CITY OF MADISON

VILLAGE AT AUTUMN LAKE

PHASE 16

REVISION 1 - 6/18/2026
 SHEETS REVISED: P1-2, O1, MN1
 SHEETS ADDED: D3-4, P3-5, X4-20

15445
O-1

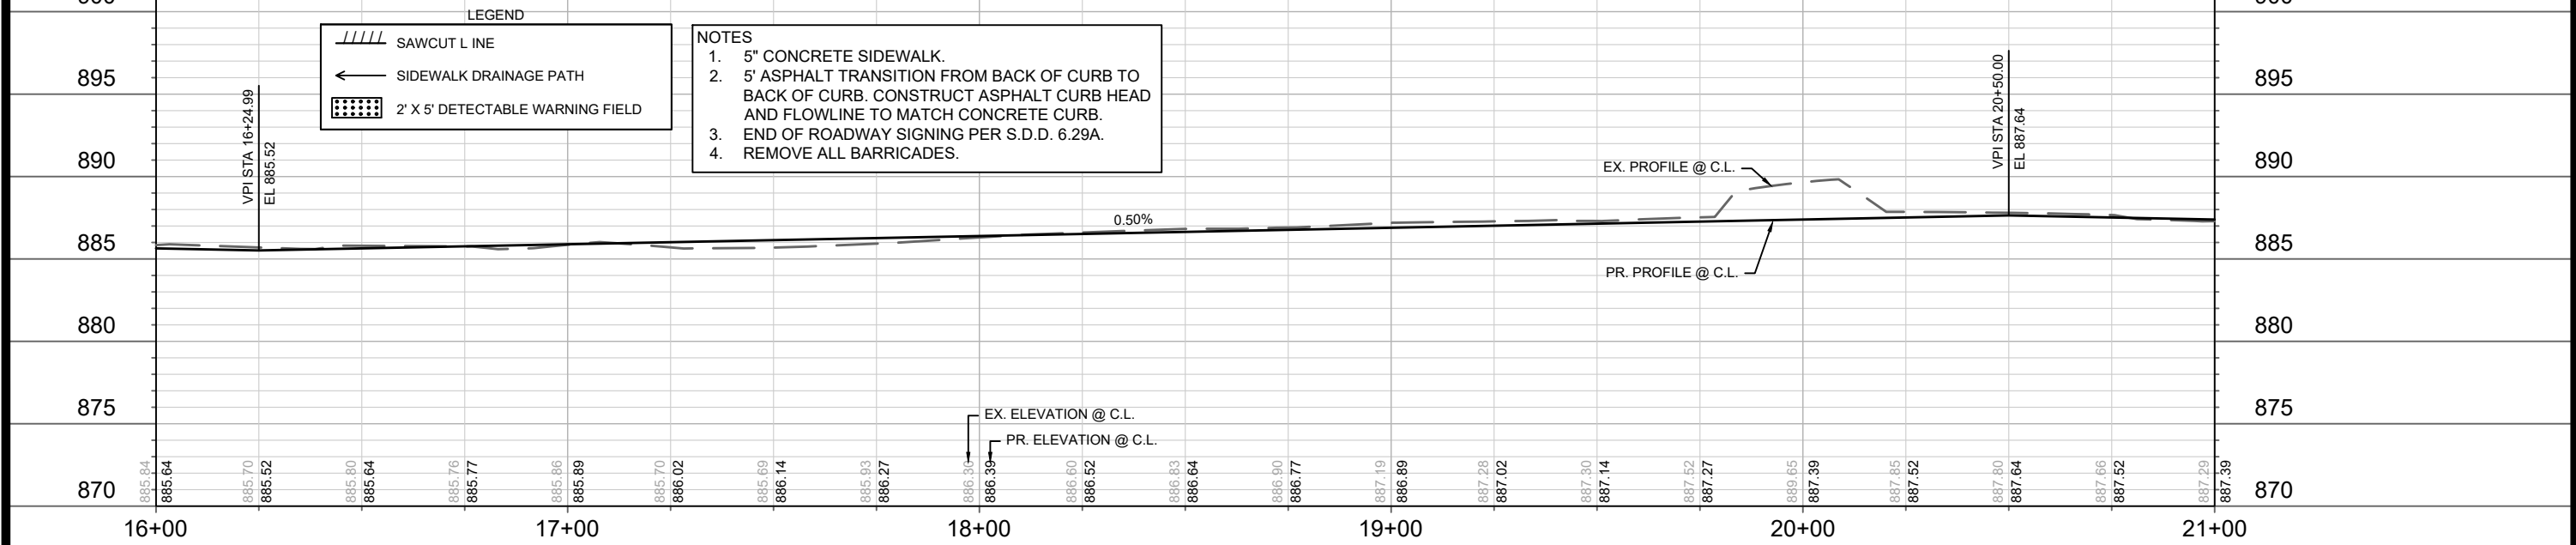
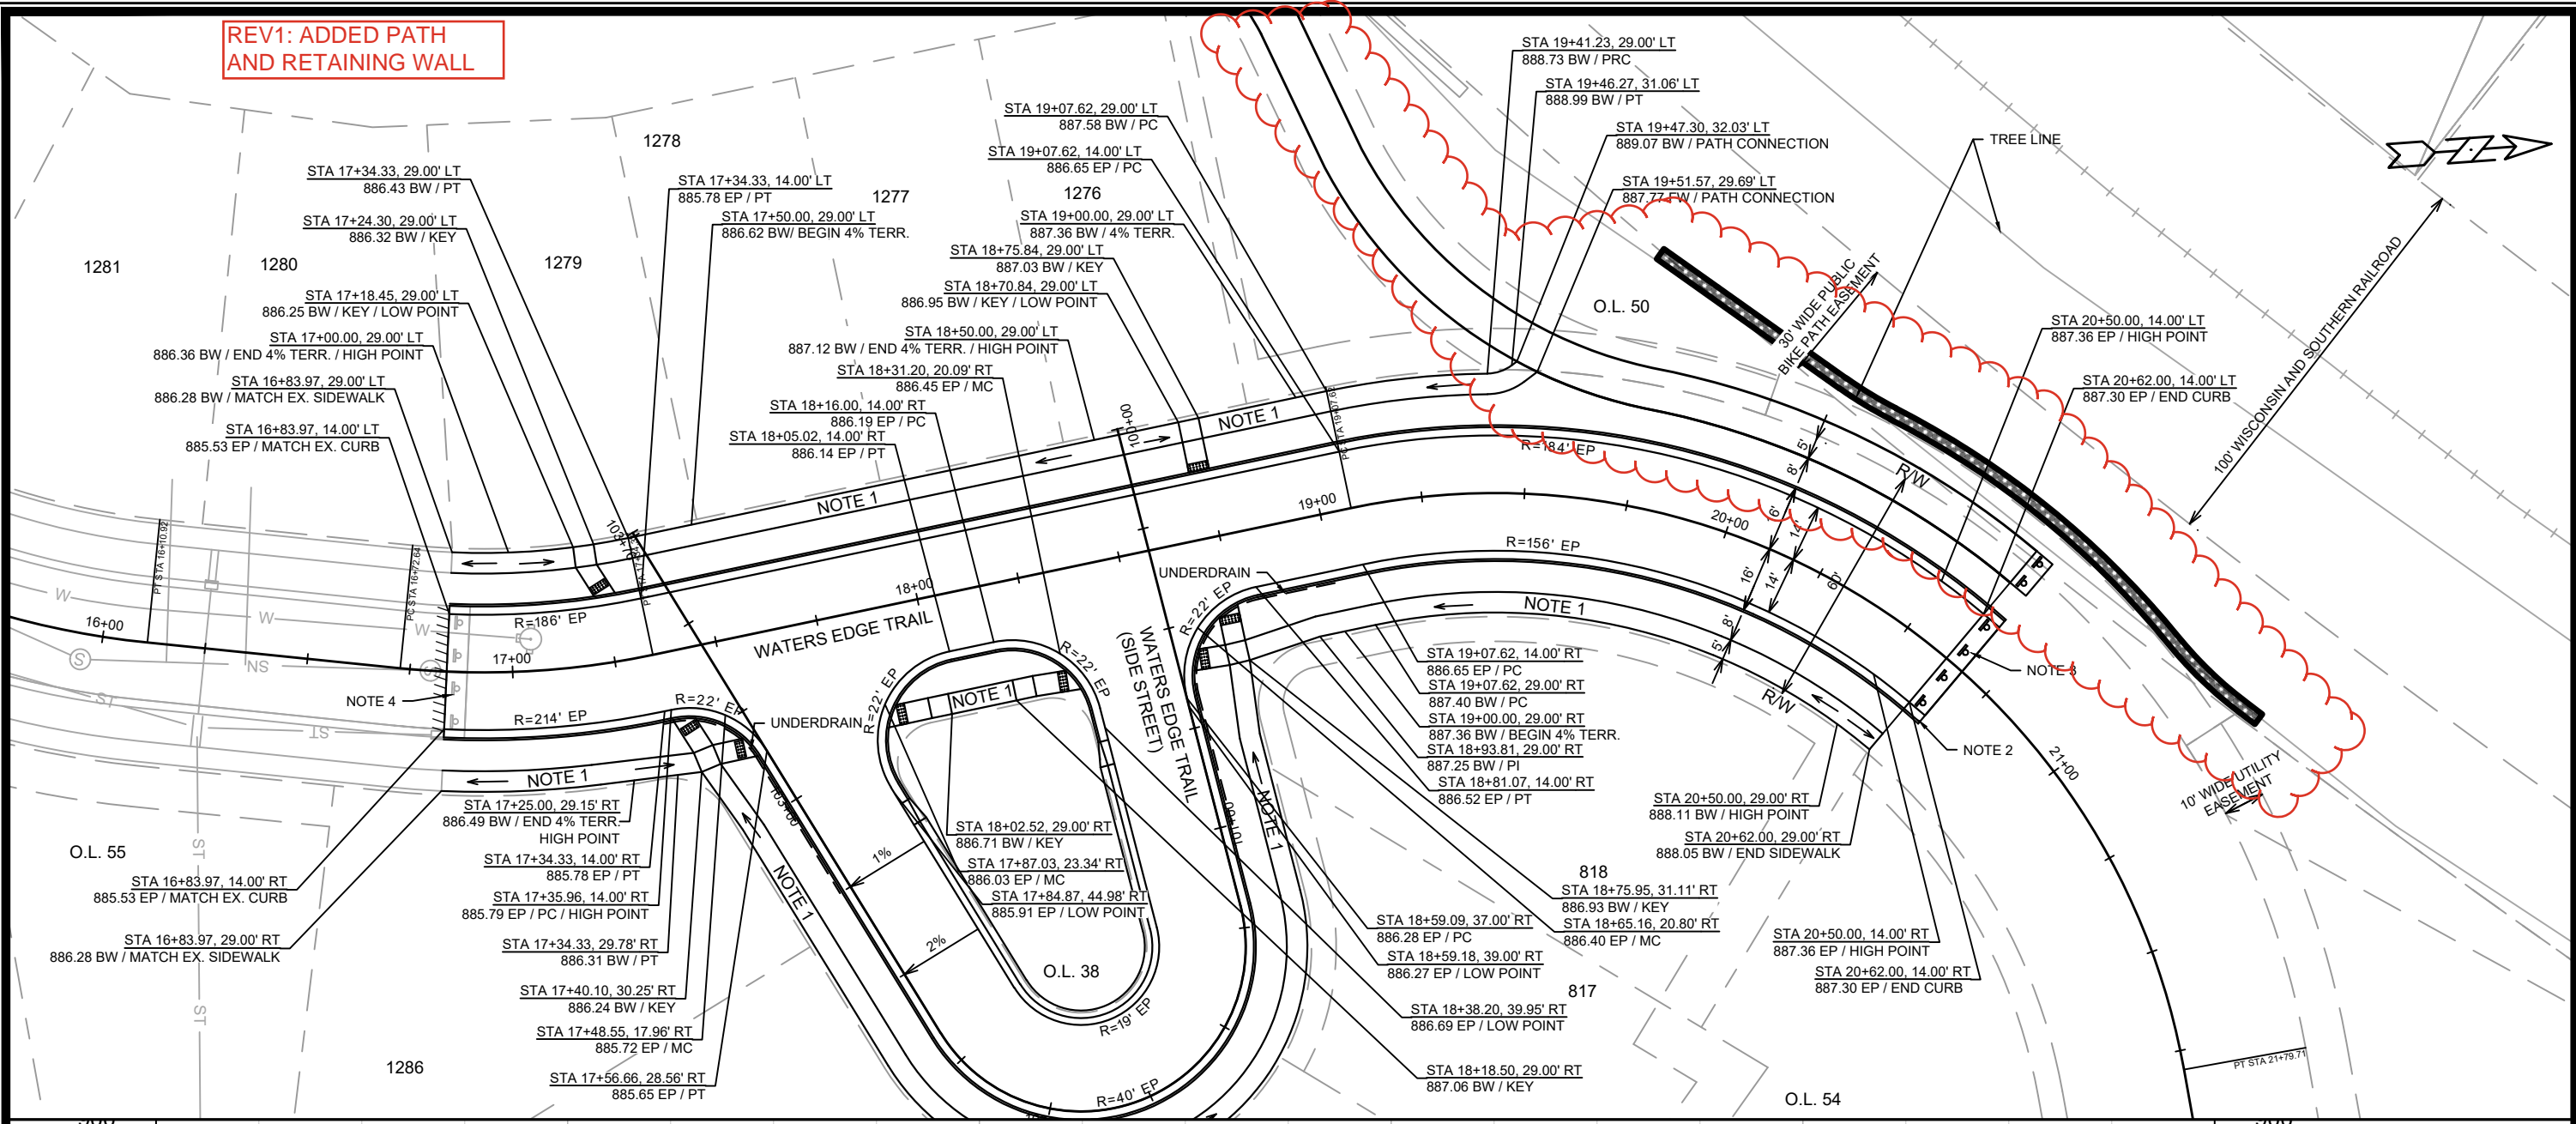
REV1: ADDED PATH AND
RETAINING WALL

PLAN AND PROFILE - WATERS EDGE TRAIL
VILLAGE AT AUTUMN LAKE PHASE 16
M:\DESIGN\Projects\15445\CAD\Streets\15445EN-PnP.dwg

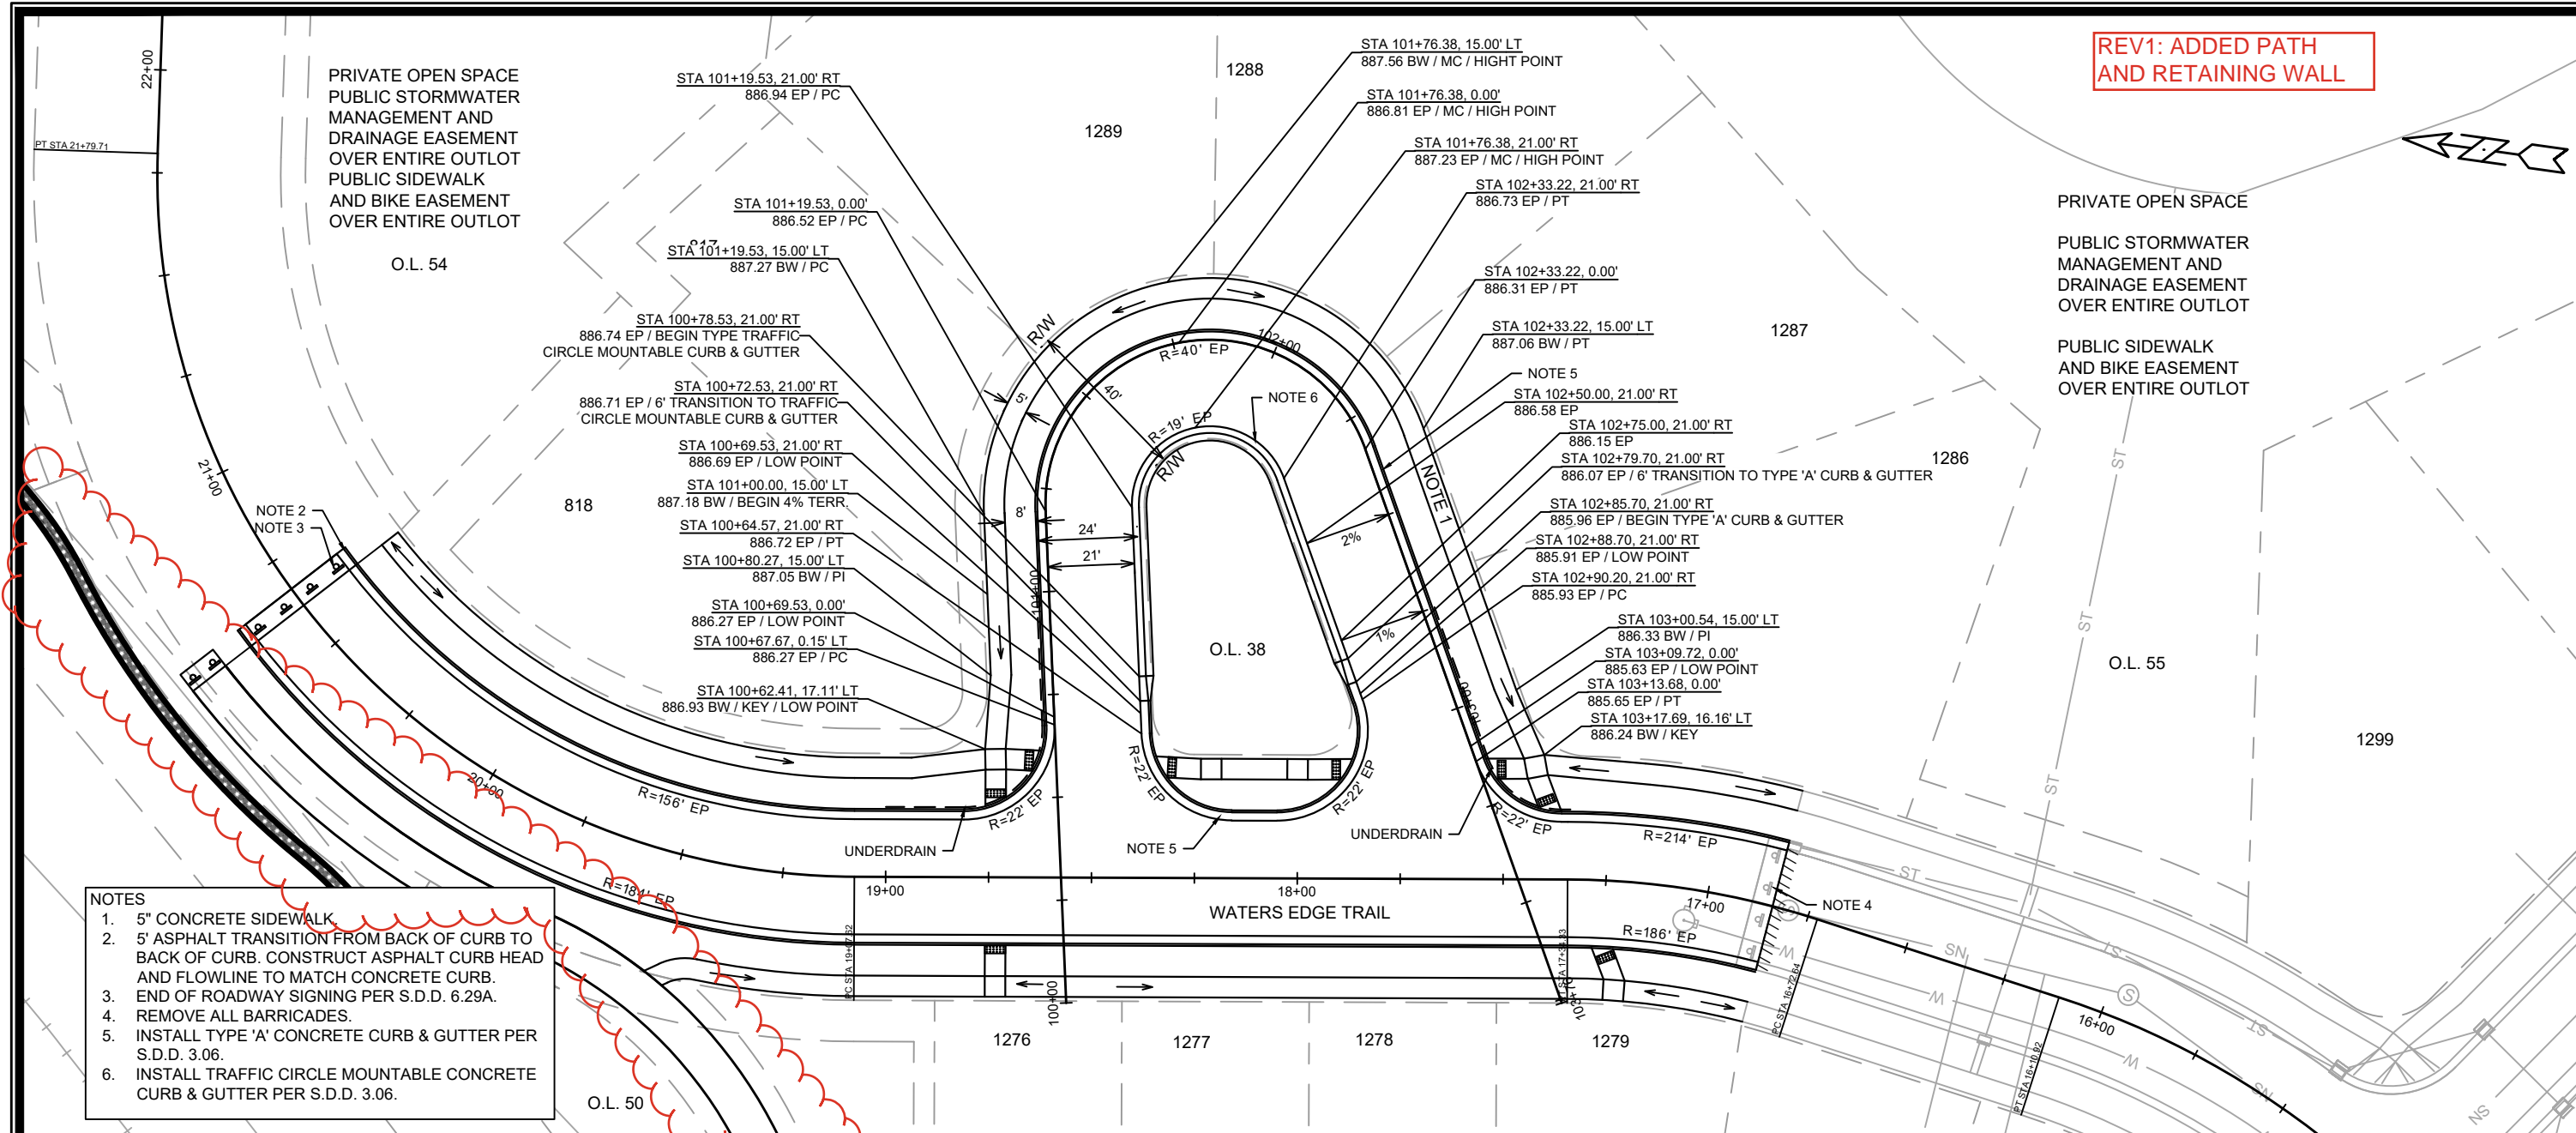
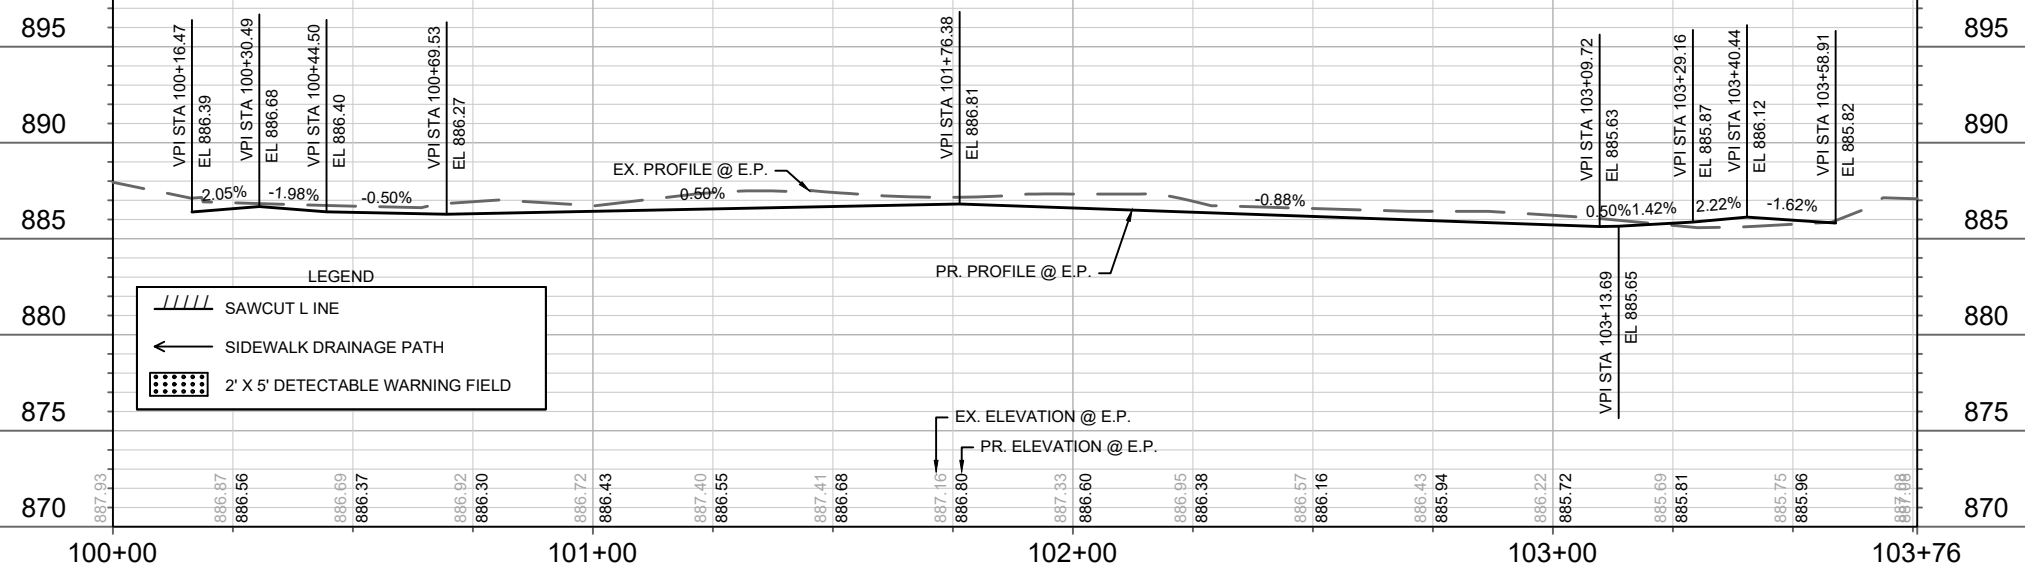
REV1: ADDED PATH AND RETAINING WALL
